Docket Number:	18-IEPR-04
Project Title:	Energy Demand Forecast Update
TN #:	224287
Document Title:	Pacific Gas and Electric Company Comments on the 2018 California Energy Demand Forecast Update
Description:	N/A
Filer:	System
Organization:	Pacific Gas and Electric Company
Submitter Role:	Public
Submission Date:	7/24/2018 2:51:45 PM
Docketed Date:	7/24/2018

Pacific Gas and Electric Company Comments on the 2018 California Energy Demand Forecast Update

**POSTED ELECTRONICALLY TO
DOCKET 18-IEPR-04**California Energy Commission
Dockets Office, MS-4
Docket No. 18-IEPR-04
1516 Ninth Street
Sacramento, CA 95814-5512Re: Docket 18-IEPR-04: Pacific Gas and Electric Company Comments on the 2018 California Energy Demand Forecast Update

Figure 1. Comparison of 2030 PG&E System CCA Load Forecast (GWh)

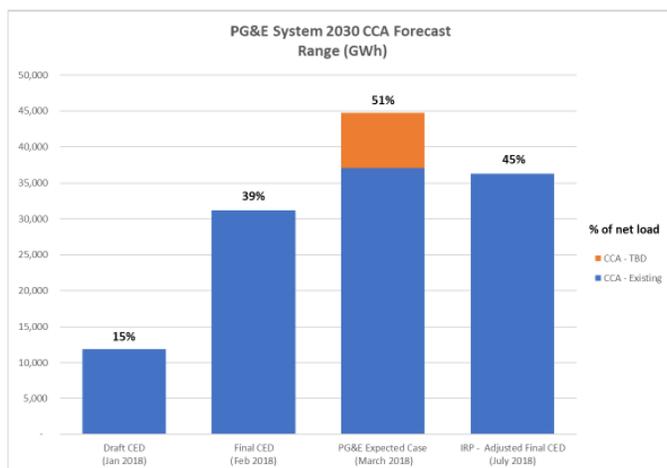
PG&E appreciates the CEC’s willingness to collaborate in improving the near-term elements in the development of its *California Energy Demand (CED) 2018-2030 Revised CCA* forecasts². The drive to integrate more recent information from CCA implementation plans into this forecast resulted in strong alignment between PG&E’s, CEC’s, and the CCAs’ year-ahead forecasts for 2019. However, as illustrated in Figure 1 below³, the CEC’s long-term forecast is 40% below PG&E’s forecast in 2030.

The CCA forecast disconnect results from the CEC’s use of an overly conservative forecast methodology, which does not appropriately capture the dynamic CCA marketplace. First, the CEC applies an *ex post* deterministic forecast method that accounts only for currently established CCAs and neglects any potential for future expansion of such CCAs. It also erroneously assumes that new CCAs will not form. The CEC acknowledges in the CED 2018-2030 Revised Forecast that the current forecast method may underestimate growth, stating that “[CCA] growth [after 2019 is] set to the average for the overall planning area. Some CCAs may see significant expansion after 2019, so this is likely a conservative forecast.”⁴

As noted earlier, the CEC’s long-term forecast is 40% below PG&E’s forecast in 2030. The CED 2018-2030 forecast abruptly terminates CCA growth beyond 2019, despite offering no rationale to support this impactful assumption regarding CCA growth. If the CEC continues to under-forecast CCA growth, it could result in an unfair cost shift to bundled Utility customers. In his remarks at the July 10, 2018 workshop, CEC Chair Weisenmiller acknowledged that the near-term and long-term uncertainty around CCA formation, expansion and commitment to implementation plans creates real challenges for the investor-owned utility (IOU) planning processes. Improved forecasting methods could help to better quantify the range of uncertainty and facilitate better decision-making.
